Access Compliance Report

Public Rights-of-Way

(Curb Ramps)

Intersection ID: 10035076	Main Street: PROVIDENCE_RD	Cross Street: N/A	Location: NE
ADA ID: 3C71B10B58A4	Ramp Type: Perp	Initial Pass/Fail: Fail	Overall Compliance: No
Codes/Mitigation Info/Possible Solution		Field Measurements/Component Compliance

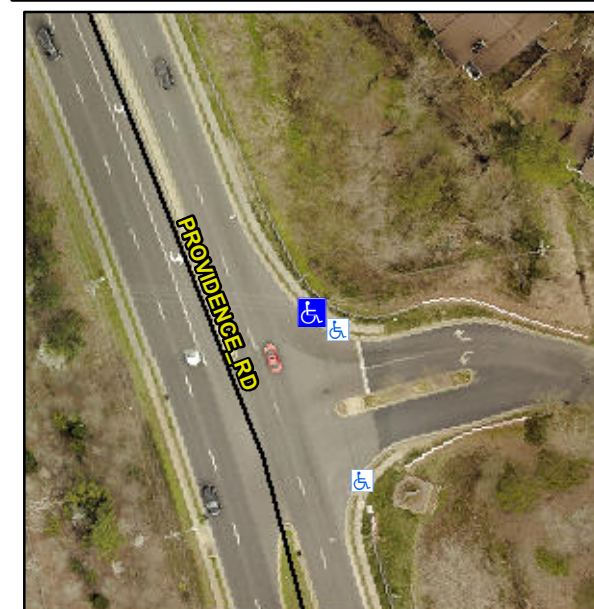
Not Found, R304.5.1, R304.5.3

Compliance	Description	Data	Compliance	Description	Data
N/A	Ramp Length (in)	72.0	Yes	Ramp Slope (%)	7.8
No	Ramp Width (in)	44.5	No	Ramp XSlope (%)	7.2
N/A	Flare Type LT	N/A	N/A	Flare Type RT	N/A
N/A	Flare Slope LT (%)	N/A	N/A	Flare Slope RT (%)	N/A
N/A	Flare Traversable LT?	N/A	N/A	Flare Traversable RT?	N/A
N/A	Landing Length (in)	N/A	N/A	DWS Provided?	N/A
N/A	Landing Width (in)	N/A	N/A	DWS Contrast?	N/A
N/A	Landing Slope (%)	N/A	N/A	DWS Length (in)	N/A
N/A	Landing X Slope (%)	N/A	N/A	DWS Full Width?	N/A
N/A	Landing Curb? (Y/N)	N/A	N/A	DWS Offset (in)	N/A
N/A	Shared Landing?	N/A			
N/A	Gutter Ponding?	N/A	N/A	Gutter Slope (%)	N/A
N/A	Gutter Lip Ht (in)	N/A	N/A	Gutter X Slope (%)	N/A
N/A	Painted X Walk1?	No	N/A	Painted X Walk2?	N/A
	X Walk 1 Direction	To W		X Walk 2 Direction	N/A
N/A	X Walk 1 Width (in)	N/A	N/A	X Walk 2 Width (in)	N/A
	X Walk 1 Slope (%)	9.1		X Walk 2 Slope (%)	N/A
	X Walk 1 X Slope (%)	2.2		X Walk 2 X Slope (%)	N/A

Remove & Replace Entire Ramp.
